SureWeld

TITLE:	1800 Axle Reinforc.
PART No:	T05084
WEIGHT:	
MATERIAL:	6mm MS
QTY/TRAILER:	4

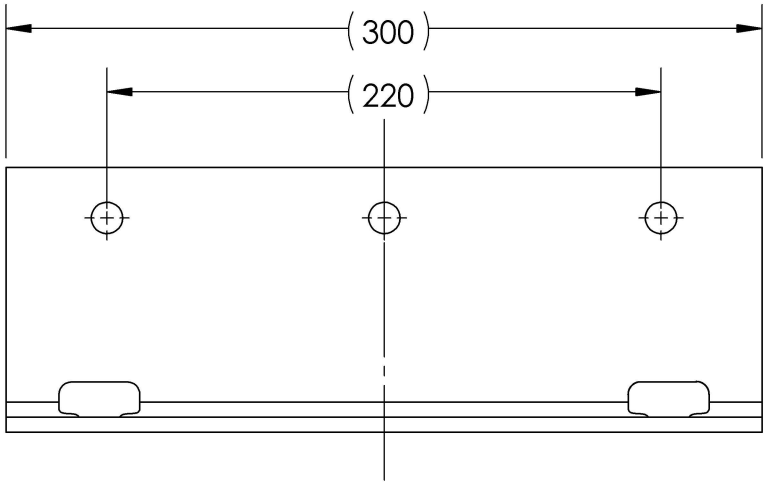
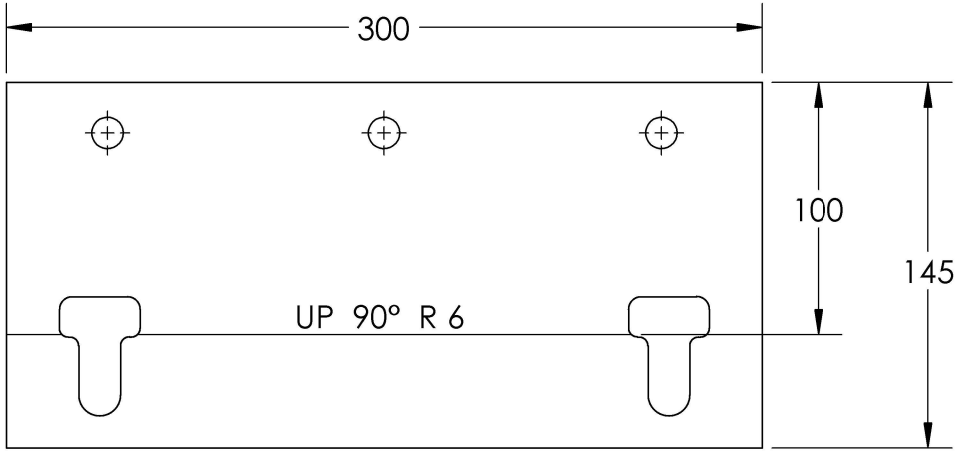
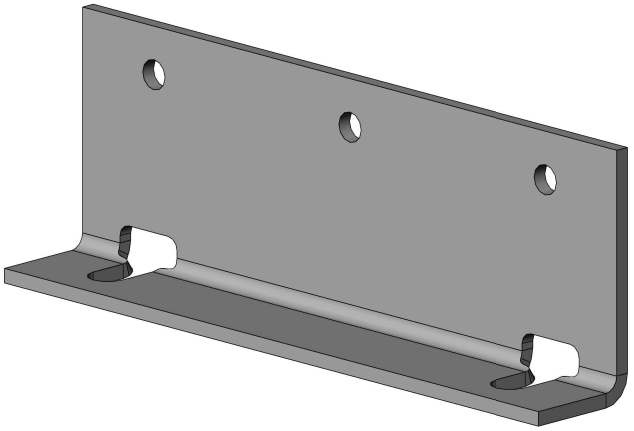
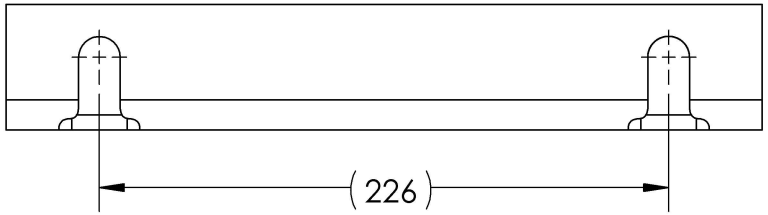
REV.	DESCRIPTION	DATE
2	AXLE MOUNT CENTRES CHANGED FROM 220 TO 226	1/03/2023
3	HOLE AND SLOT SIZING INCREASED BY 0.5mm	6/11/2025
